High Knob Observation Tower

Errata – Drawings and Specifications

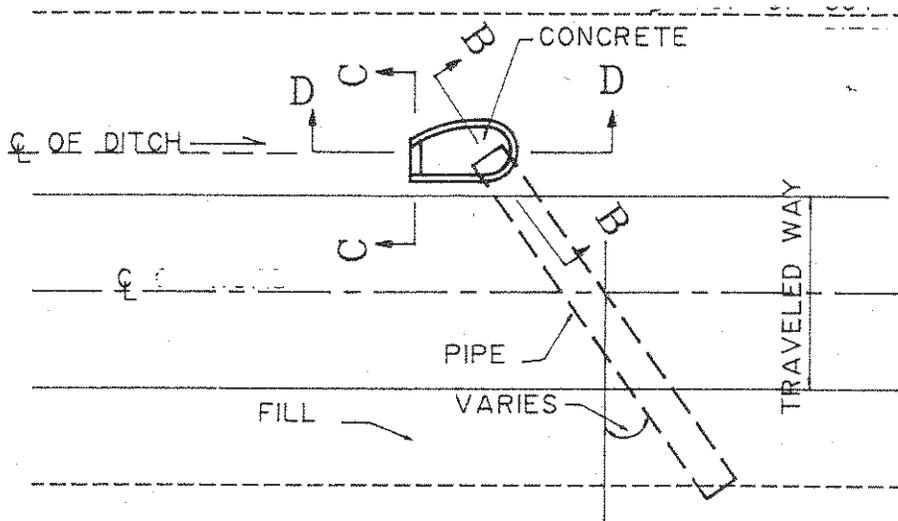
1. Replace the word “Architect” with “Government” where found within the text of the specifications, attached reports and plans.
2. Omit select landings on non-sloping portions of the trail as indicated on Figure 1.

5. Provide a trapezoidal bed (2 ft wide entrance, 6 ft wide exit, 8 ft length and 1 ft depth embedded 10-12 inches into grade) of natural rounded stone rip-rap (5 - 10 inch diameter) as energy dissipaters at the outlet of each cross trail grate trough as indicated on Figure 1. The exit of all dissipaters shall be anchored with the largest stones to prevent rock loss. No stone bedded trapezoidal dissipaters shall be located on the portion of the trail between the tower and the sundial.

Figure 3

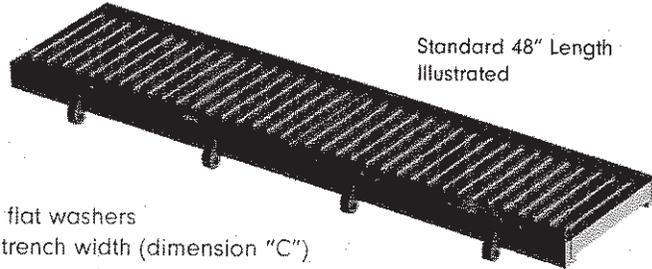
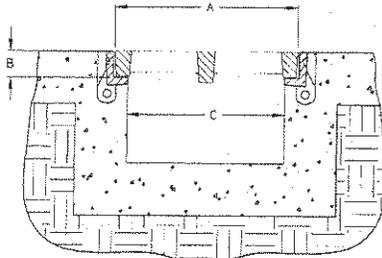
4. Provide cross trail grated troughs at the front (upslope end) of indicated landings in the concrete aggregate portion of the trail. Trail landings and cross grate troughs shall be monolithic poured concrete units (see attached Figure 3). Apply an exposed aggregate surface on the trail landings identical to surface of concrete walk sections near the tower. Drainage grates shall be a removable type, bolted into a frame embedded into the concrete. Drainage grates shall comply with ADA standards such as East Jordan Iron Works V-7380 series or equivalent.
